**PLANNING COMMISSION
THURSDAY, APRIL 1, 2021 6:00 PM**

1. Application #2021-5020; 1220-1222 South Waggoner Road; Applicant JAS Builders, LLC; Major Site Plan (Wilson Ridge Townhomes)

RE: 1220-1222 South Waggoner Road (Parcel ID Nos. 060-008195, 060-009282, 060-000208) – Major Site Plan #2021-5020 Staff Report

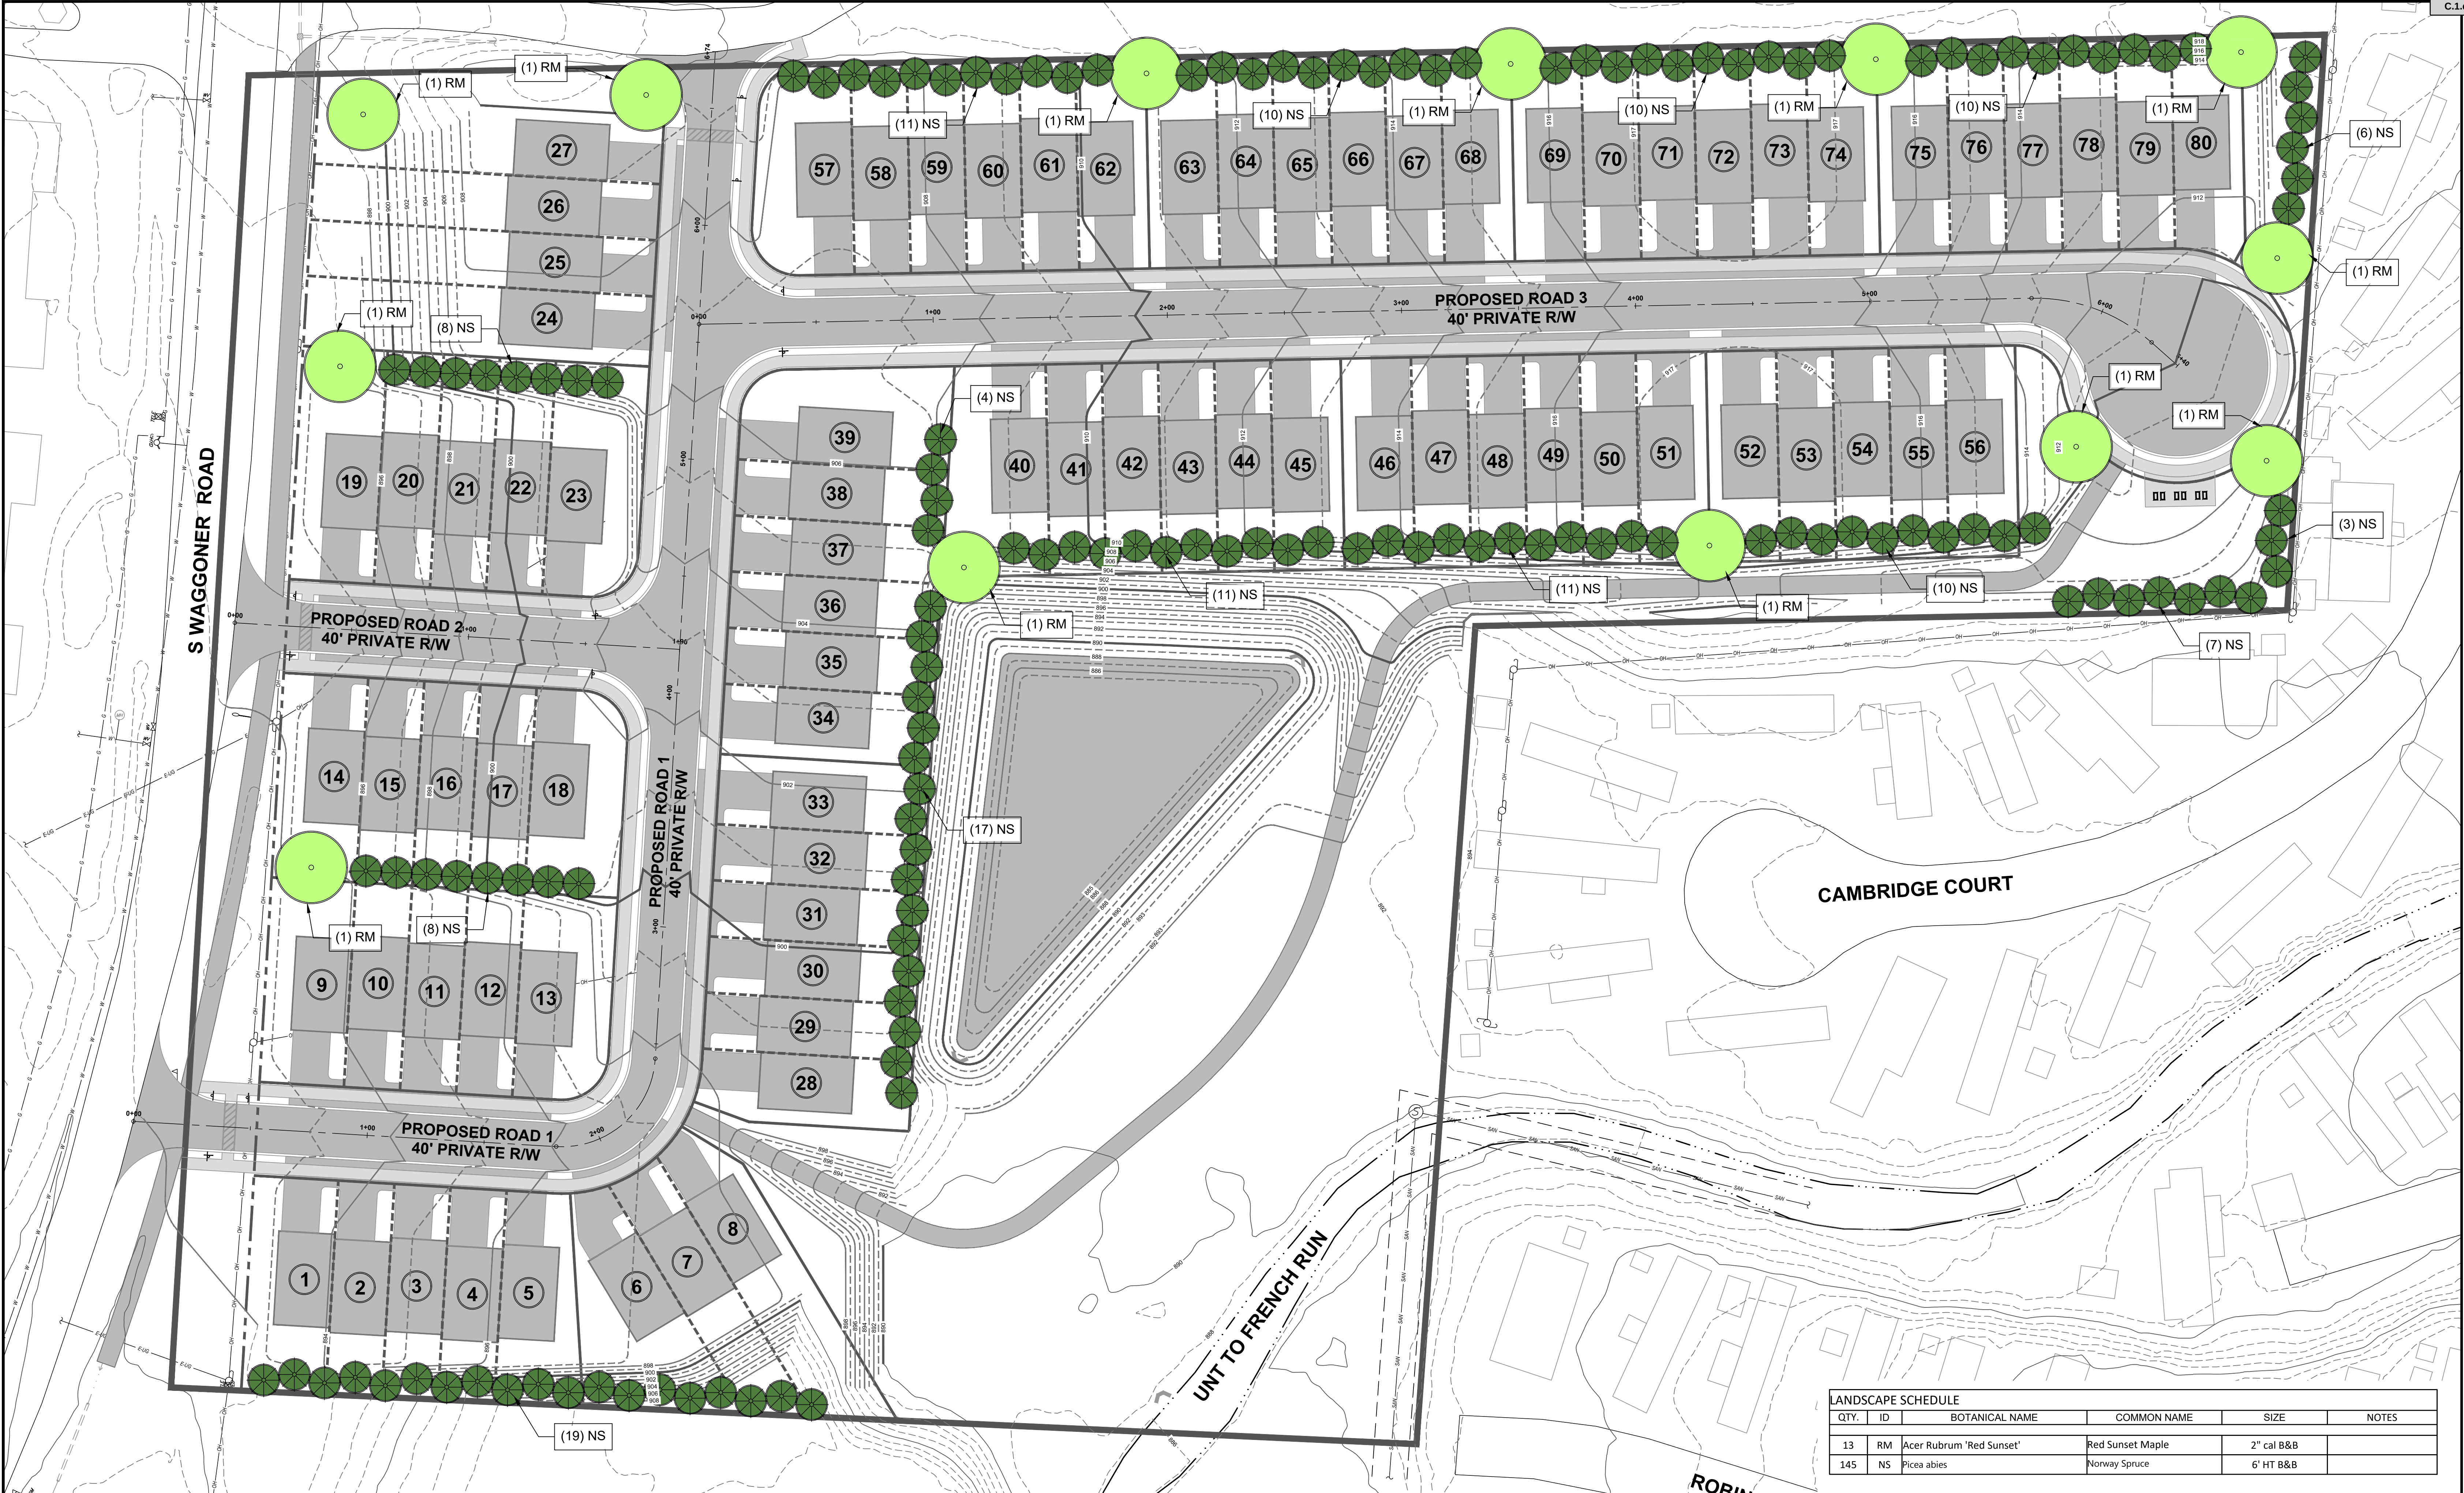
Mr. Hicks: Thank you, Mr. Chairman. I appreciate that. I want to thank everyone here tonight. So I had a few questions, I was going to pull up my notes here. A few questions in regards to the plan, I think we have some technical things. In respect to the landscape plan, just reviewing what's being proposed in the landscape plan. I don't see any landscaping along Waggoner Road and I don't see any street trees along the interior private roads. Those are a little bit concerning. And then my third comment on the landscape plan is that it's basically just two species of red, maple and blue spruce or some sort of evergreen, but there's not like a variety of species. Just working in the industry, it just seems like I think we learn from some of the

blights of ash, some of those things and try to mix up the species of the different trees in them and the community so that if there's ever something that takes out one particular species, that the particular development wouldn't get kind of wiped out all the trees. So I think those were my comments on the landscape plan. I had a question in regard to the setback on Waggoner Road. Obviously, one of the biggest issues with folks that live on Waggoner Road is the traffic. The city has been taking the initiative to come up with a plan to be able to improve Waggoner Road over a number of years and multiple phases in order to address a lot of those problems. And I just want to make sure, because I don't see anything on the drawings that says what the setback is from whatever the new property line will be on that part of the parcel from Waggoner Road. So if you guys if anybody could address that, I would appreciate it just to make sure that it meets our code in regards to that would be a front yard setback.

Mr. Hicks: I would just say to approve something that within a year we know is going to become a nonconforming issue. So, you know, that doesn't impact all the units. It's just probably three townhouse units along there, maybe, maybe just two. But I just want to make sure that's being addressed here. I'm not crazy about having two separate curb cuts. I think we've covered this on a different proposal and Planning Commission member Benner and I have discussed this just having two different curb cuts along Waggoner road and both of them being full access. I don't even think the last one that we had was full access. And that kind of ties into the traffic study. Well, the traffic letter that we received that didn't calculate the number of trips. Seeing enough of these calculations and the traffic study trips, my only comment would be it appears based upon the number of units that your unit count be below what's going to be required for a traffic access study for city use requirements. All the other submissions that we've had before this, there were actual counts still provided for that. So I didn't see those, unless I missed those. I would like you to also please address that. And then my final comment would just be building elevation's specifically side elevations. I believe we got some side elevations and I think their expectation would be that there would be some upgraded elevations for the buildings that face Waggoner. Those are obviously very close to Waggoner Road, very visible and as of right now, have absolutely no landscaping in front of

them. And we would want to see that those would be high quality in order to ensure that they look nice on Waggoner Road. So those are all of my comments trying to be as concise as possible and that will be it. Thank you, Mr. Chairman.

Mr. Furst: Gentleman just to speak to as well, because I was at the BZBA meeting, the developer has agreed to a zero dollar grant additional right away if it's necessary to make those Waggoner Road improvements. But also, Mr. Bowsher kind of dovetailing with Mr. Hicks point about the landscaping, is it outside of the question that we could maybe get the city to commit to planting some trees, at least along the Waggoner Road when you do those developments? Because that's typically kind of how that road is landscaped.

Mr. Furst: Well, I wouldn't want to. The problem is, I wouldn't want to plant trees once again, like the path you'd have to tear up to widen the road.

Mr. Bowsher: I think that's a fair point. I think also discussing that with the developer today on if they're willing to add additional landscaping, sort of buffer for that.

Mr. Bowsher: No, I totally agree. I guess what I was getting towards is, number one, which it doesn't look like they have a lot there. So if we're asking them to put that there, that's fine. Then we'll work with them to come up with a dollar amount. So that could be planted there after those road improvements were done.

Mr. Spagnola: We will. We definitely will. What we proposed here was just a proposed landscaping plan. When we go through engineering, we'll tweak this up and we'll add some landscaping along Waggoner Road.

THE WEXFORD FRONT LOADED COTTAGE
BASEMENT LEVEL ENTRY WITH FRONT GARAGE

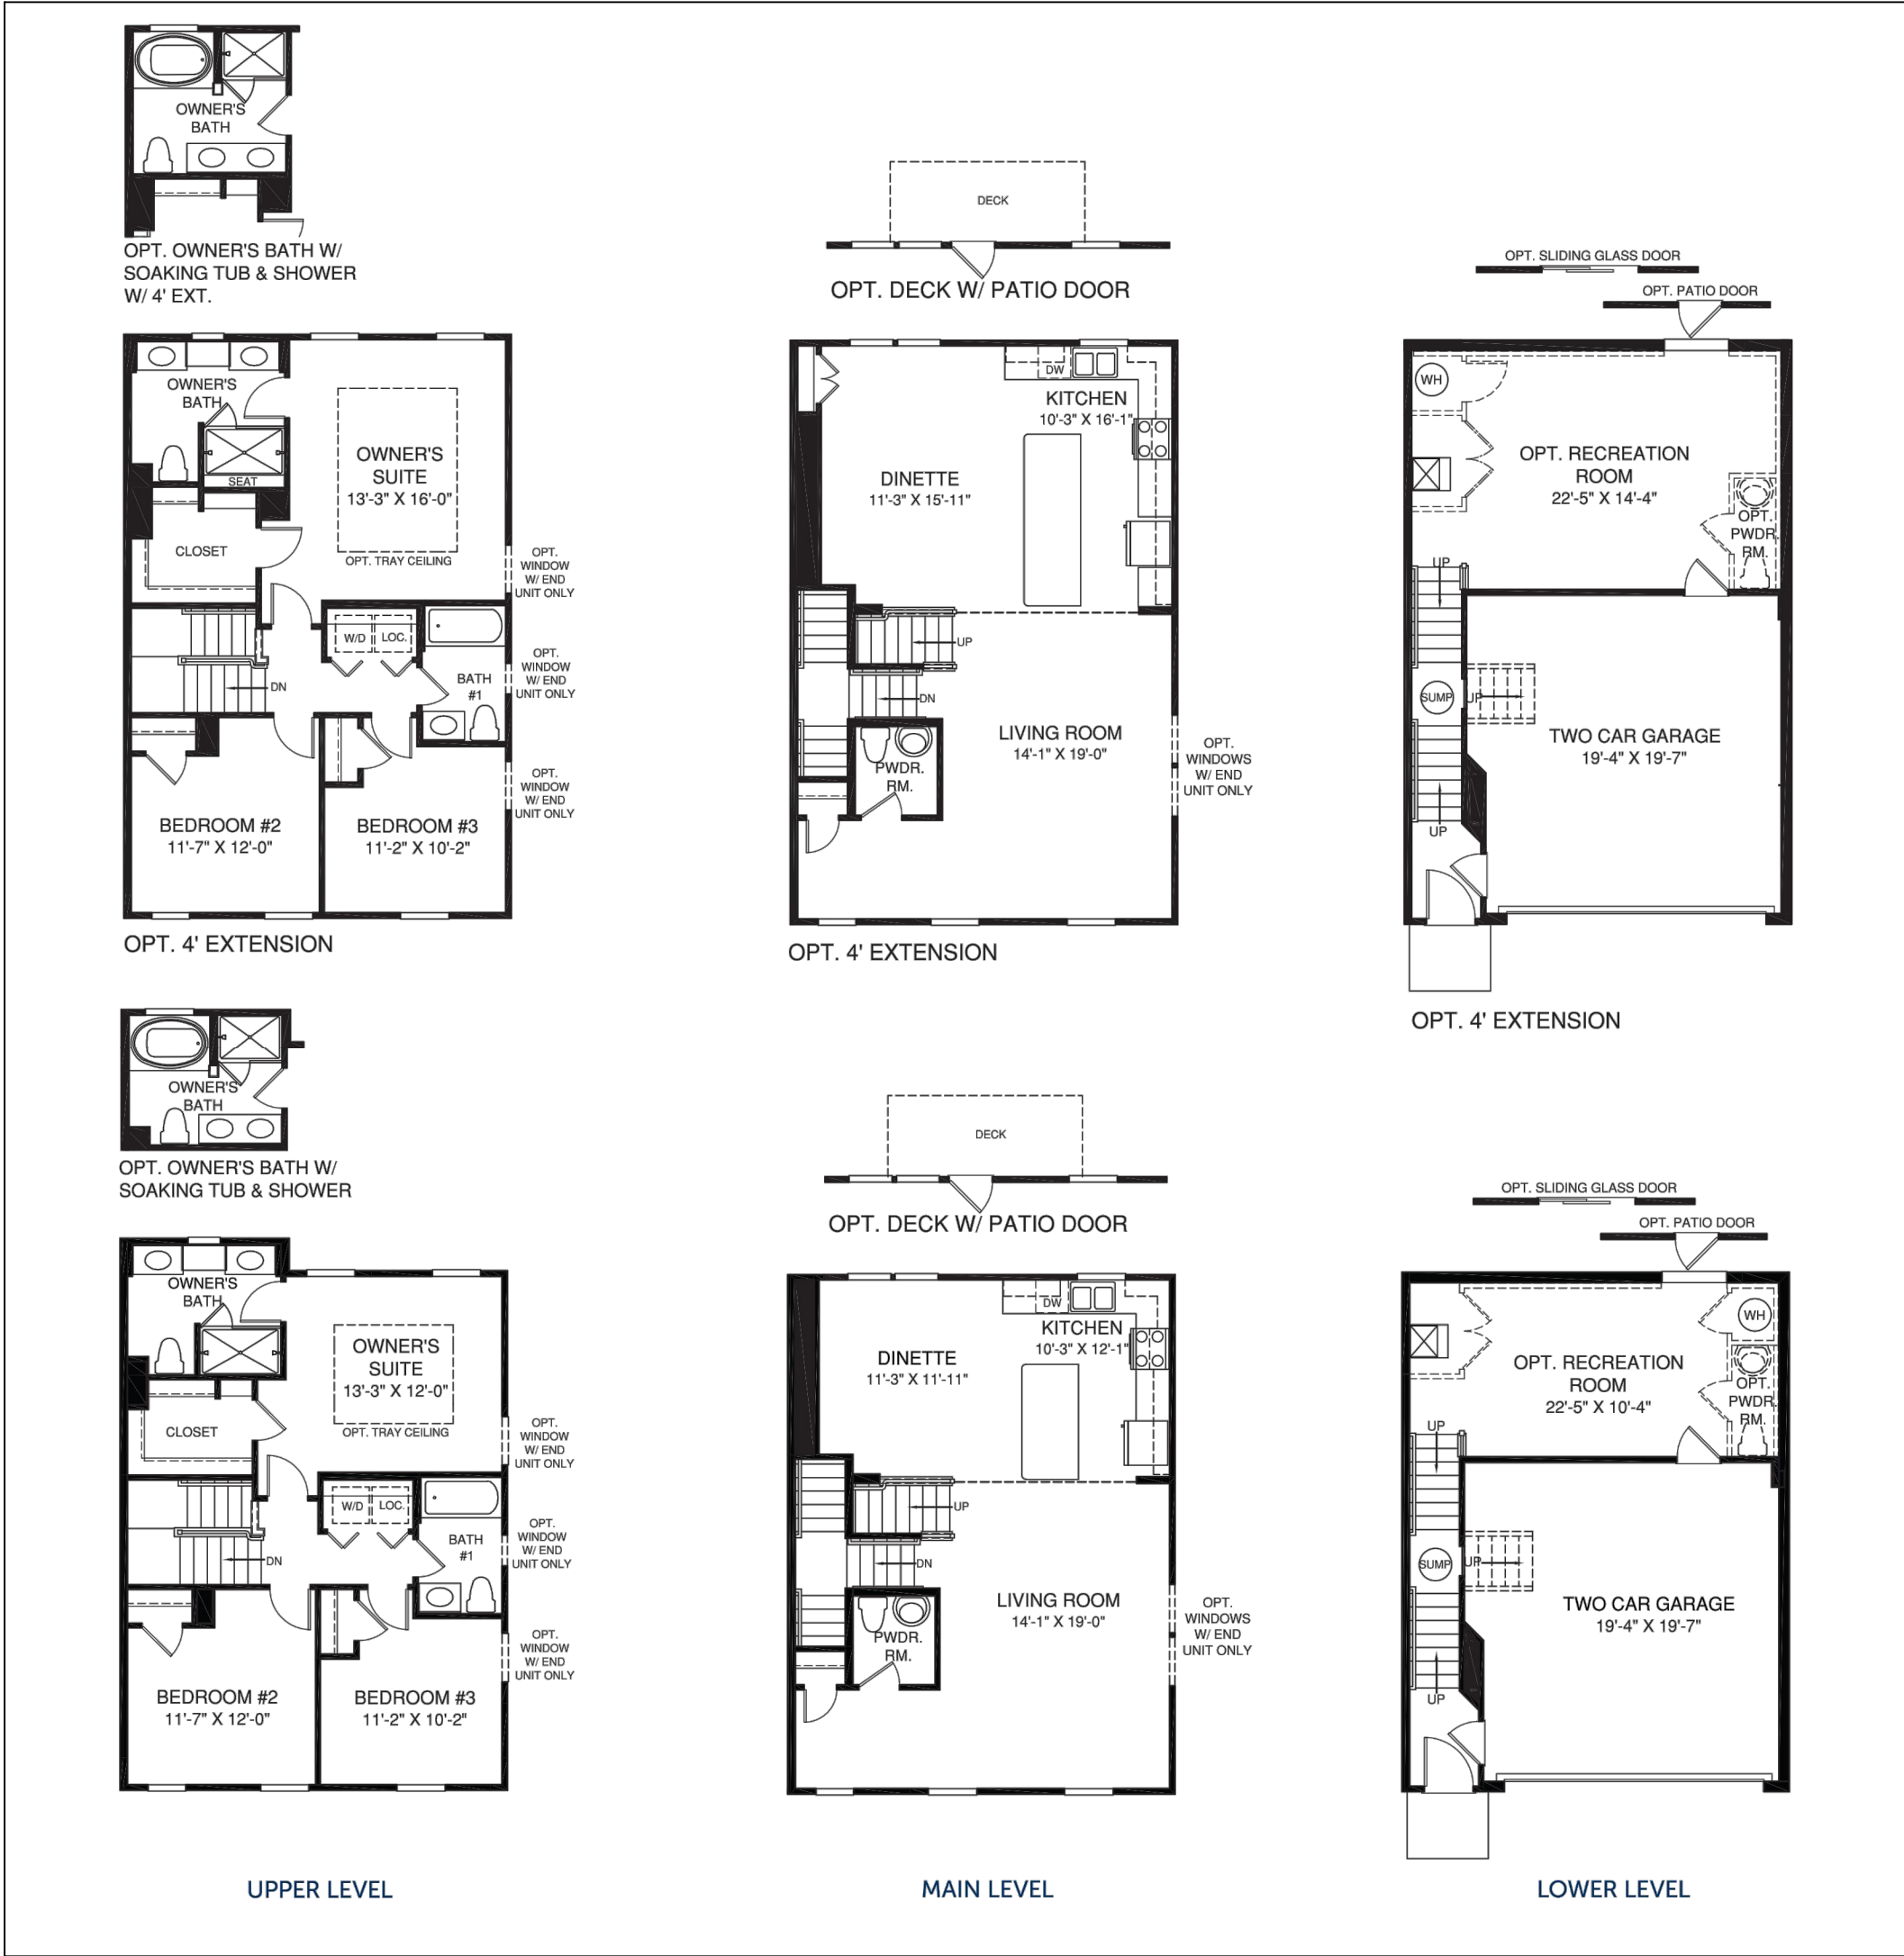
Mr. Zollars: While we're looking for that, can someone tell me the height of these buildings?

Mr. Zollars: I have a question, one of the things that Mr. Hicks addressed was the front look of the Waggoner Road facing properties. Any early thoughts from the developer on what to do to modify, enhance that a little bit?

Mr. Moore: I do know that they're; I know the reason you ask that question. I do know that we proposed this same building at Rosehill and they are under the height requirement for Reynoldsburg.

Mr. Brown: This Jason Brown with Ryan Homes. As you mentioned, we certainly have several of those options. So once we kind of finalize the landscaping plan to see what fits, I'm looking at several options right now. Broken up by three, four or five windows on one example with both siding stone or vertical board and baton shake shingles. So we have plenty of those options to choose from. So I think it just whatever look matches over there, we can certainly solve that on those three, four or five elevations that are along Waggoner.
